Product Advisory

Issue Date: 13-November-2023

Tray changes for BCM54214 & BCM54216

Tray pocket design change:

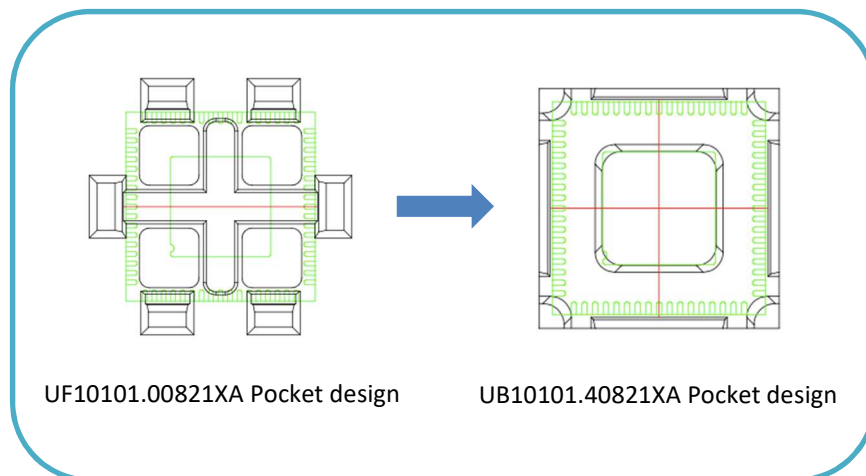
Change from Ubot UF10101.00821XA to Ubot UB10101.40821XA

Same Pitch: M=11.95, M3=16.00, M1=11.00, M2=14.65

Same Matrix: 8x21
